The International Standard: “Reed Switches - Part 1: Generic Specification” (IEC 62246-1 Ed. 2)

Critical Review

Vladimir Gurevich, Ph. D.,

Israel Electric Corporation

Fig. 6. Oscillograms of switch-on and switch-off processes in the reed switch
 t_5 ; t_6 ; t_{15} ; t_{16} – contact bounce times (Fig. 2 from standard IEC 62246-1 Ed.2)

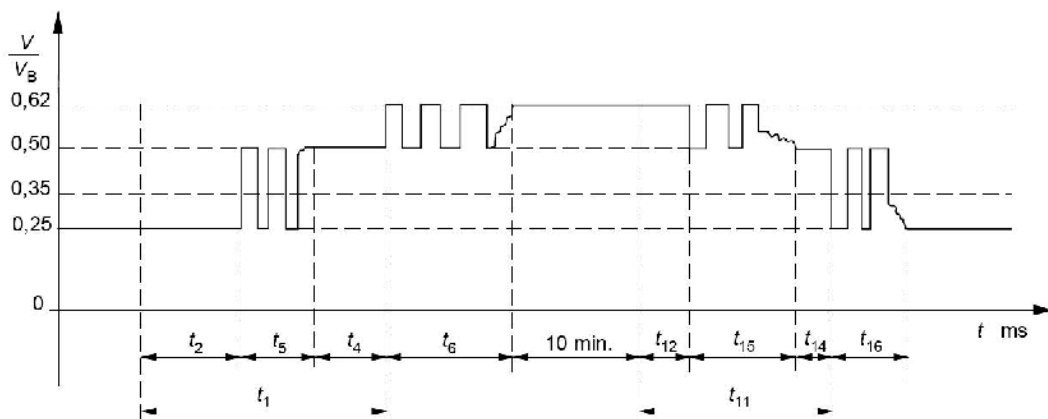
And further, what does the note about “without breaking applies” and “without making applies” in the procedures mean for making and breaking current capacity test (Sections 7.32.2 and 7.33.2)? How it is possible to realize this demand practically, if, according to the standard’s claim (Section 3.2.13, Fig. 2), the switching process is always accompanied with contact bouncing? In contrast to Fig.2, the figure in Annex G (Making current capacity test sequence) and the figure in Annex H (Breaking current capacity test sequence) do not include contact bouncing. So, which figure is correct?

It is absolutely clear that all these Sections need to be completely rewritten.
